REMARKS

M:\TNACCARELLA\CLIENTS\LUCCENT\23770\PATENT OFFICE\AMENDMENT TO 10- -03 OA.WPD

FIG. 1 — PRIOR ART-
ADDED

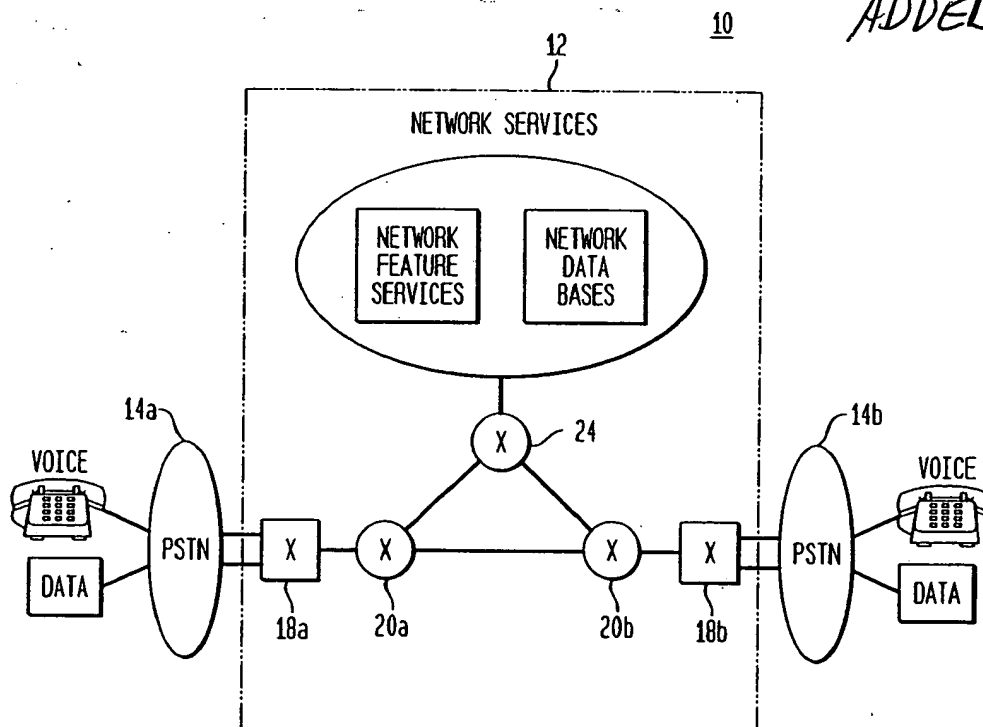
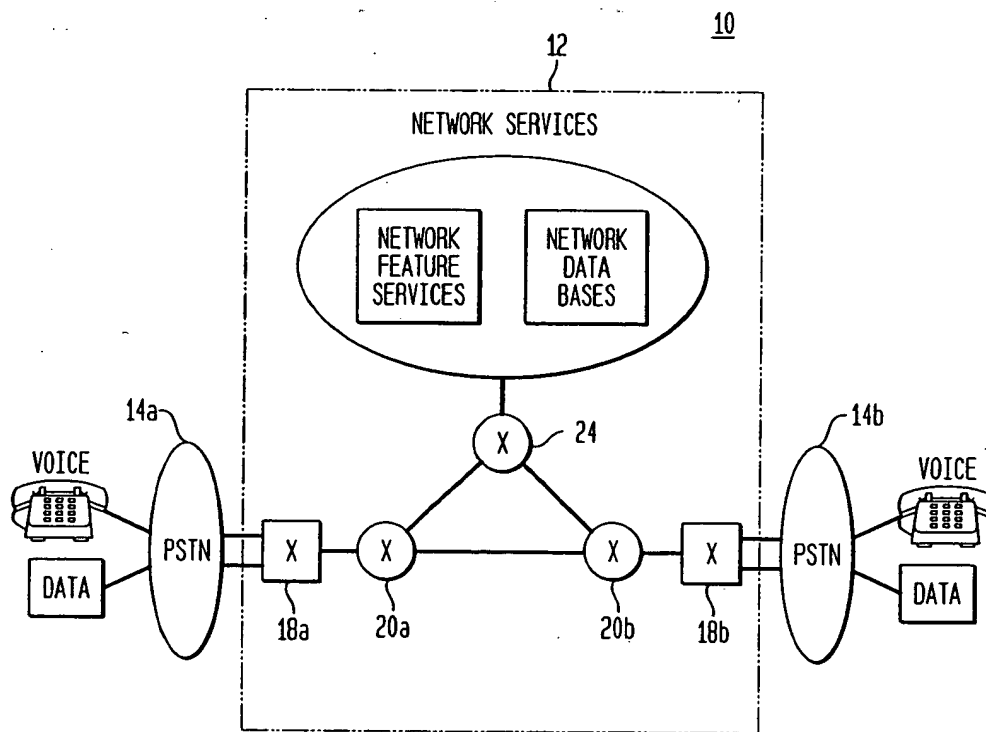
In Section 1 of the Office Action, the Office asserted that Figure 1 should be designated by a legend such as – PRIOR ART --. Applicant has amended Figure 1 accordingly.

FIG. 3A

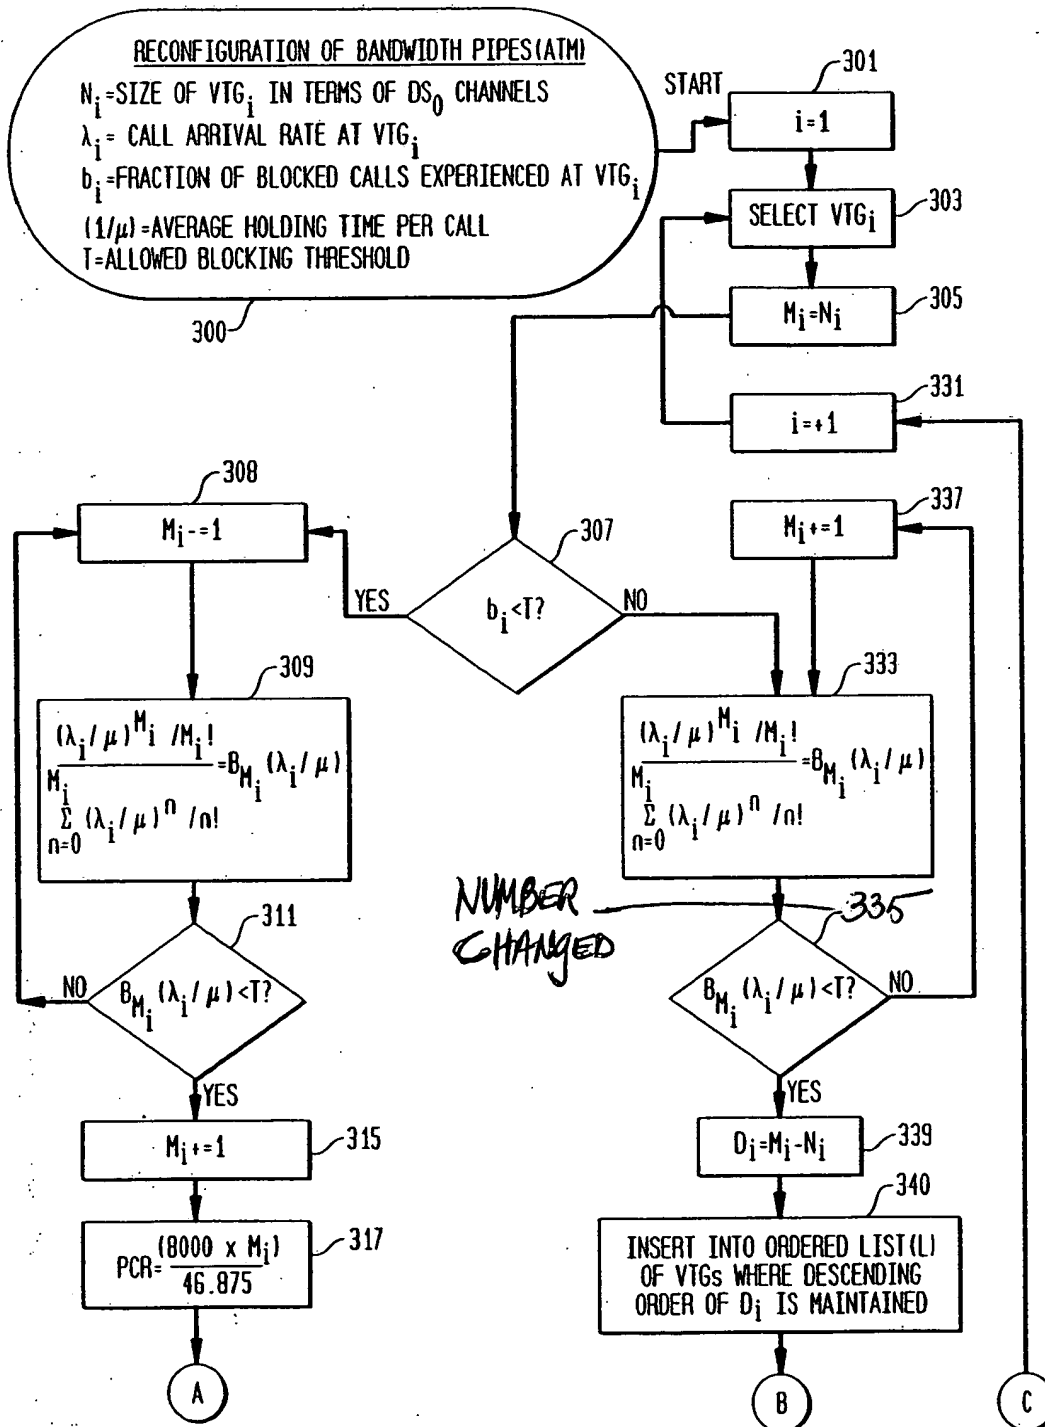
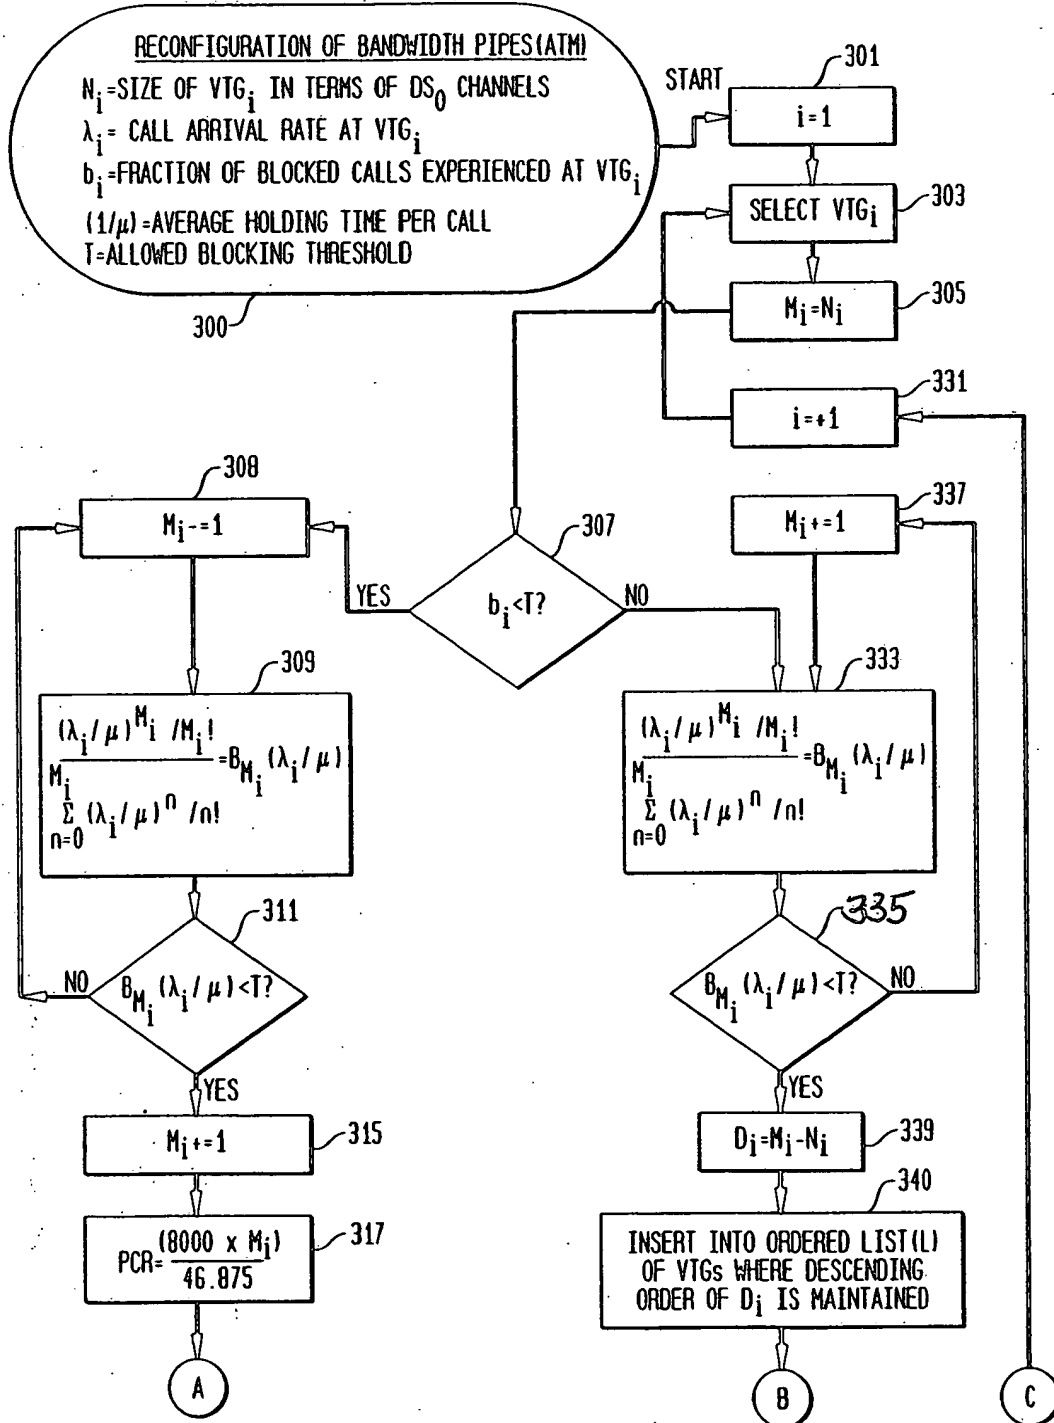
In Section 3 of the Office Action, the Office further objected to the drawings because reference numeral 311 located after reference numeral 333 in Figure 3 should be relabeled as reference numeral 335 in order to match page 25 of the specification; “if” should be “is” in step 641 of Figure 6C; and reference numeral 924 in Figure 9B should be relabeled as reference numeral 935 in order to match page 56 of the specification. Applicant submits herewith proposed drawing corrections in accordance with the Office’s remarks.
